Well Name: EXXON 33 FED

Notice of Intent

Type of Action: Plug and Abandonment

Exxon 33 Fed Com 1P&A Procedure

CURRENT WBD

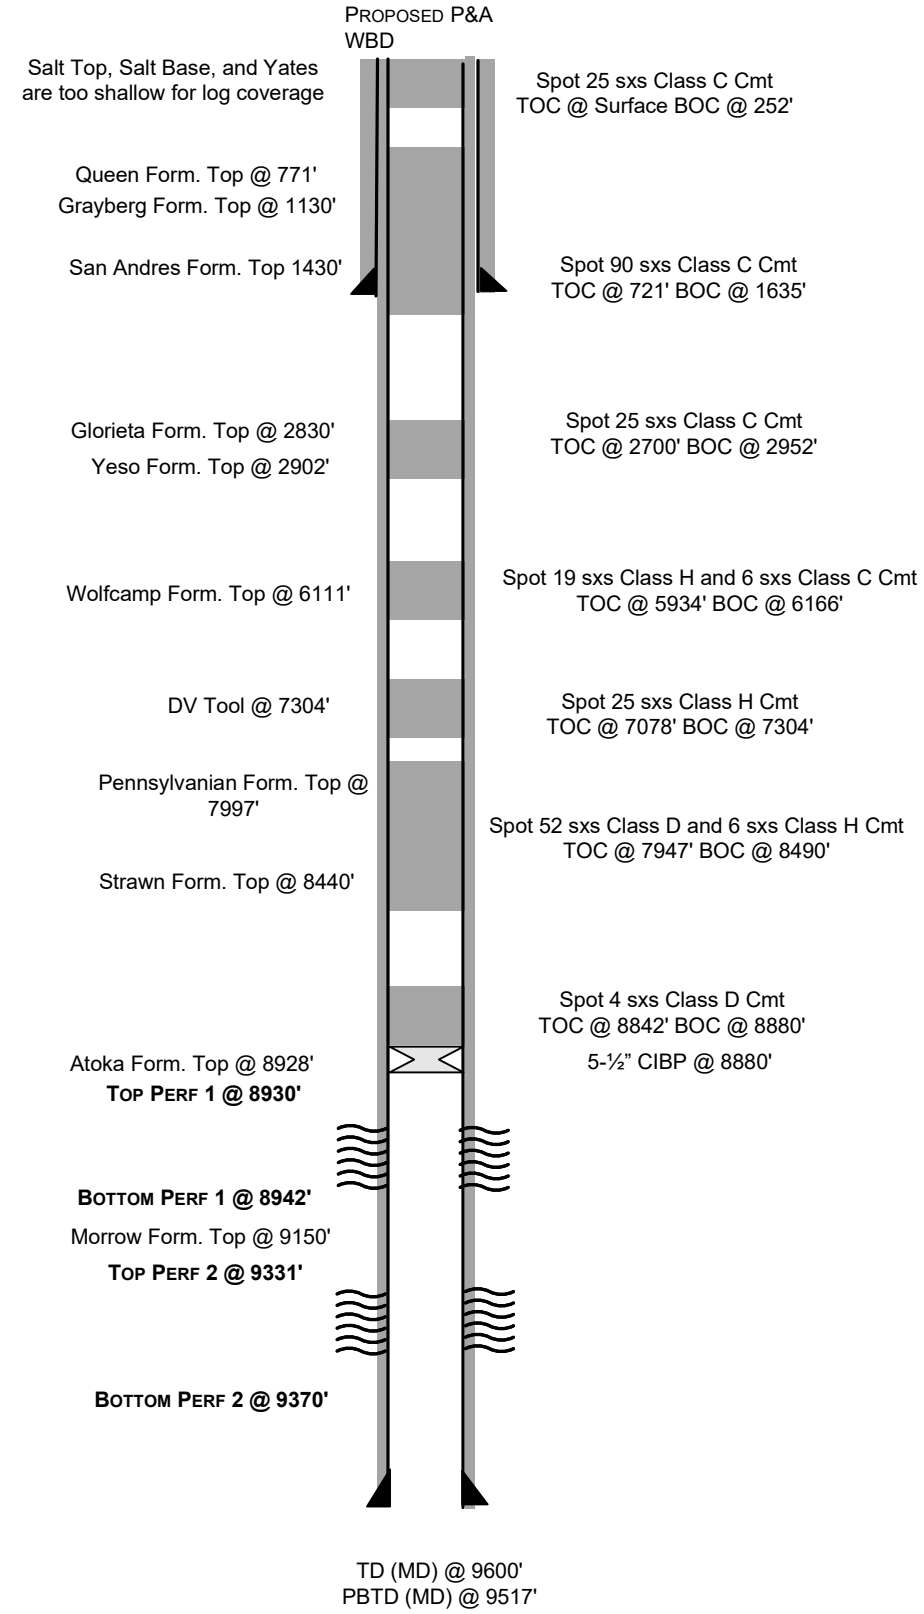
BLM Revised P&A Procedure

1. Notify BLM 24 hrs prior to starting operations.
2. MIRU WOR.
3. Check for pressure on tubing. Kill well if necessary.
4. NDWH & NU BOP. Release pkr & TOH w/ tbg.
5. TIH w/ CIBP on tbg & set @ 8880'. Run CBL from 8880' to surface. **Contact BLM after running CBL.** Spot Cl H cmt from 8880' to 8842'. Pressure Test. **WOC and Tag.**
6. Spot Cl H from 8490' to 7947'. **WOC and TAG (T/Strawn, T/Pennsylvanian).**
7. Spot 25 sx Cl C from 7304' – 7078'. **WOC and TAG (DV Tool).**
8. Spot Cl C from 6166' - 5934'. **(T/Wolfcamp).**
9. Spot 25 sx Cl C from 2952' to 2700'. **WOC and TAG (T/Yeso, T/Glorieta).**
10. Spot 25 sx Cl C from 1635' to 721'. **WOC and TAG (T/San Andres, T/Grayberg, T/Queen, Surface shoe).**
11. Spot 25 sx Cl C from 252' to surface.
